**PLANNING DEPARTMENT ADMINISTRATIVE PUBLIC HEARING
SUMMIT COUNTY, UTAH
May 15, 2025**

Planning Department Staff Report

Subject: 121 Sampson Avenue
Application: PL-24-06125
Author: Meredith Covey, Planner I
Date: May 15, 2025
Type of Item: Historic District Design Review

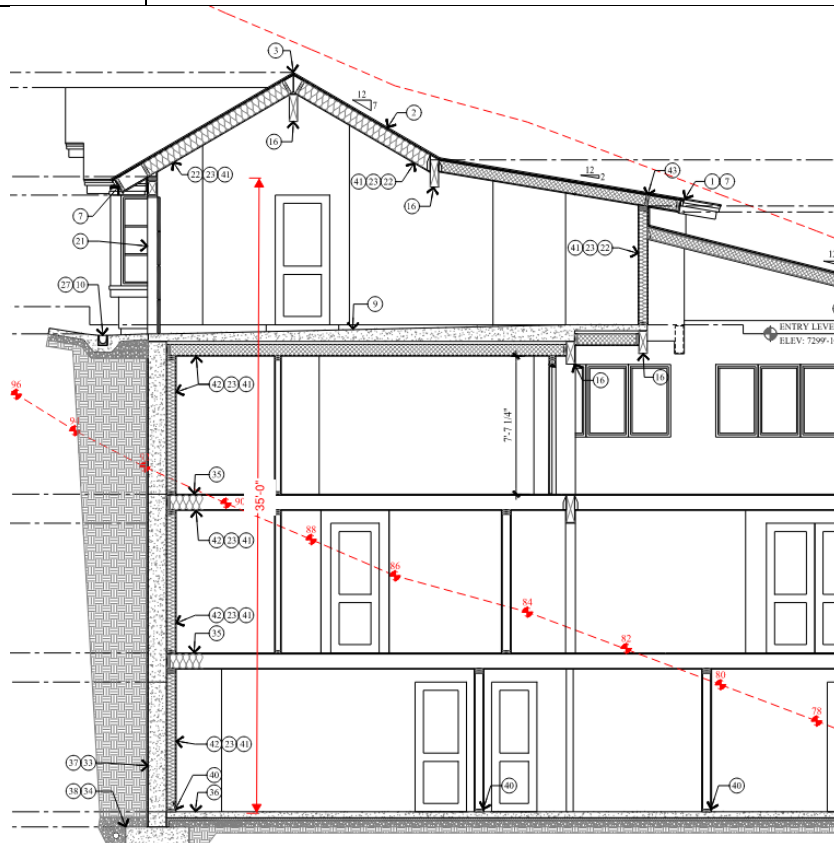
Maximum interior height of 35 feet, measured from the lowest finished floor plane to the point of the highest wall top plate that supports the ceiling joists or roof rafters

Complies: The proposed maximum interior height of the Structure is 35 feet as shown below:

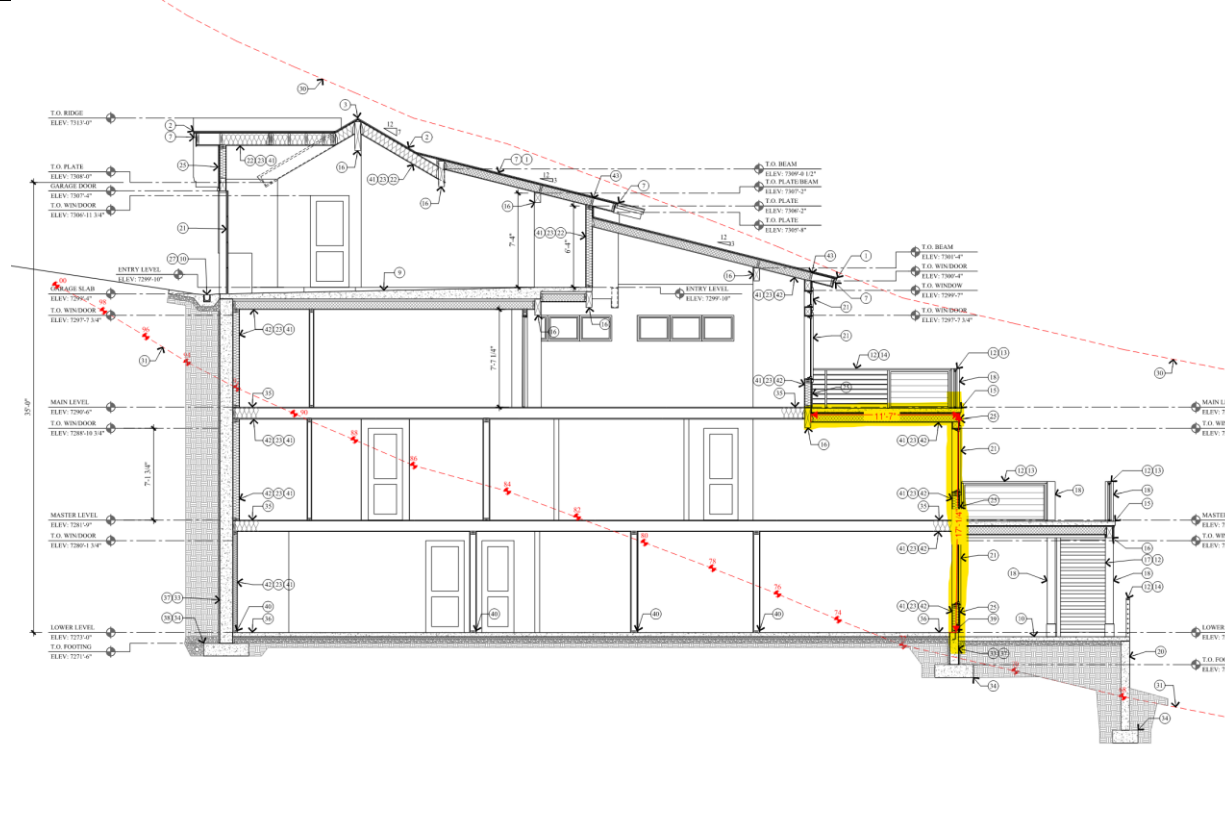
A ten foot (10') minimum horizontal step in the downhill façade is required. The horizontal step shall take place at a maximum height of twenty-three feet (23') from where the Building Footprint meets the lowest point of existing Grade.

Complies: The structure steps back 11 feet 7 inches at 17 feet 1/4 inches as shown below:

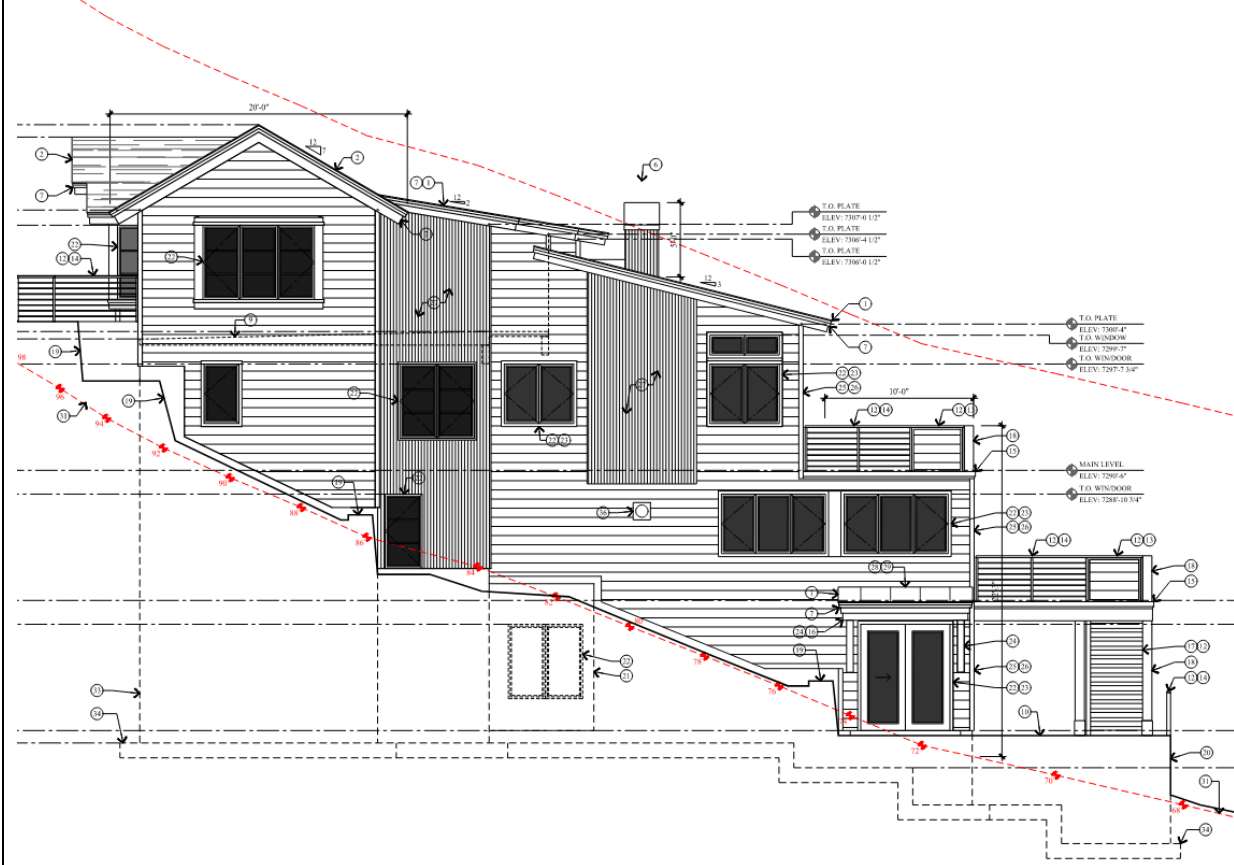
The roof pitch of a Structure's Contributing Roof Form shall be between seven: twelve (7:12) and twelve: twelve (12:12) and shall occupy a minimum horizontal distance of 20 feet measured from the primary façade to the rear of the building, as viewed from the primary public right-of-

As demonstrated in the proposed plans (Exhibit B) the roof pitch at the front of the Structure is a 7:12 pitch and extends 20 feet when measured from the primary public right-of-way to the rear of the building.

way. Secondary Roof Forms may be below the required 7:12 roof pitch and located on the primary façade (such as porches, bay window roofs, etc.).	
Final Grade within 4 feet of Existing Grade	Complies: The proposed final grade is within four feet of existing grade as shown below: Pursuant to LMC § 15-2.1-5, Final Grade must be within four vertical feet (4') of Existing Grade, except for the placement of approved window wells, emergency egress, and a garage entrance. The proposed window well serves as emergency egress and is compliant with LMC § 15-2.1-5.

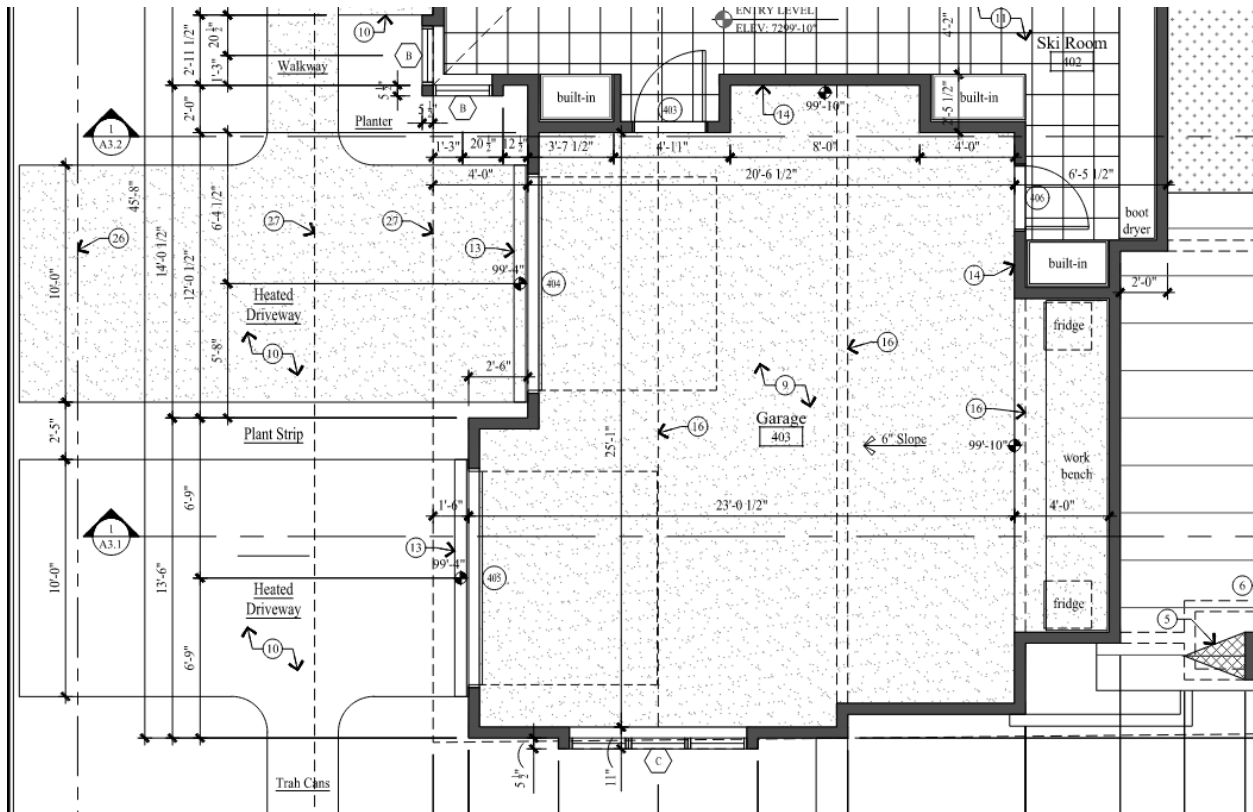
Pursuant to LMC § [15-3-6\(A\)](#) two parking spaces are required for a SFD. The Applicant proposes a double car garage accessed by two separate driveways.

LMC § [15-3-4\(A\)\(1\)](#) requires double car garages must be at least twenty feet (20') wide

by twenty feet (20') deep. The proposed garage, which is accessed by two separate driveways, is 25 feet wide and 23 feet deep and is compliant with LMC [§ 15-3-4\(A\)\(1\)](#).
